PRODUCT CHANGE NOTIFICATION (PCN)

A-MCU60005/B MODULAR CABLE

CHANGE NOTIFICATION: PCN 20220509_A-MCU60005/B

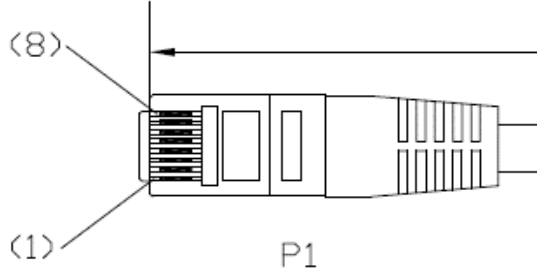
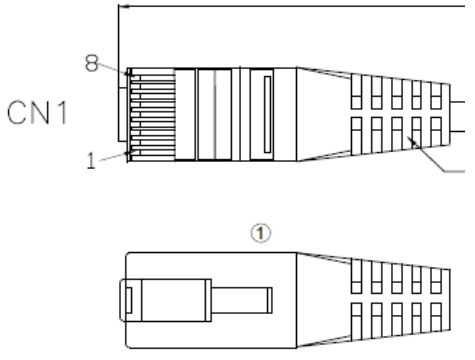
DESCRIPTION OF CHANGES: CHANGE OF DATA SHEET
CHANGE OF DATA SHEET
New Draw.-No. ASS_8285_CArev01

REASON FOR CHANGE: CHANGE OF PRODUCT LOCATION
CHANGE OF PRODUCT LOCATION

A-MCU60005/B OLD VERSION	A-MCU60xxx/x NEW VERSION																				
<p>Appearance</p>  <p>BOM</p> <p>Material:</p> <ul style="list-style-type: none"> Conductor: 26AWG 7*0.16±0.015mm Conductor Insulation color coding: (1)White/Orange, (1)Orange, (1)White/Green, (1)Green, (1)Blue, (1)White/Blue, (1)White/Brown, (1)Brown Included printing on cable jacket: CM (UL) C(UL) 4P 26AWG UTP CAT.6 PATCH CABLE ISO/IEC & EN & ANSI/TIA-568-C.2 Cable Assembly: White cable tie, Wiring T568B color, Plug RJ45 8P8C 3µ pc UL 94V-2 Cable Jacket color: Grey 	<p>Appearance</p>  <p>BOM</p>

①	△	Molding PVC	2	Molding PVC 65P	①	△	RJ45 CONN	2	RJ45 8P8C, contacts 3u" gold-plated Un-shielded PC UL94V-2	①	△	CABLE	1	CAT6 U/UTP(26AWGx1PR)*4+Cross+PVC Jacket OD:5.0±0.3mm	NO.	NAME.	Q'TY	SPECIFICATION	
①	△	Molding PVC	2	Molding PVC 65P																	
①	△	RJ45 CONN	2	RJ45 8P8C, contacts 3u" gold-plated Un-shielded PC UL94V-2																	
①	△	CABLE	1	CAT6 U/UTP(26AWGx1PR)*4+Cross+PVC Jacket OD:5.0±0.3mm																	
NO.	NAME.	Q'TY	SPECIFICATION																		
<p>FOR DETAIL, PLEASE TAKE ATTACHED NEW DRAWING: FOR REFERENCE</p>
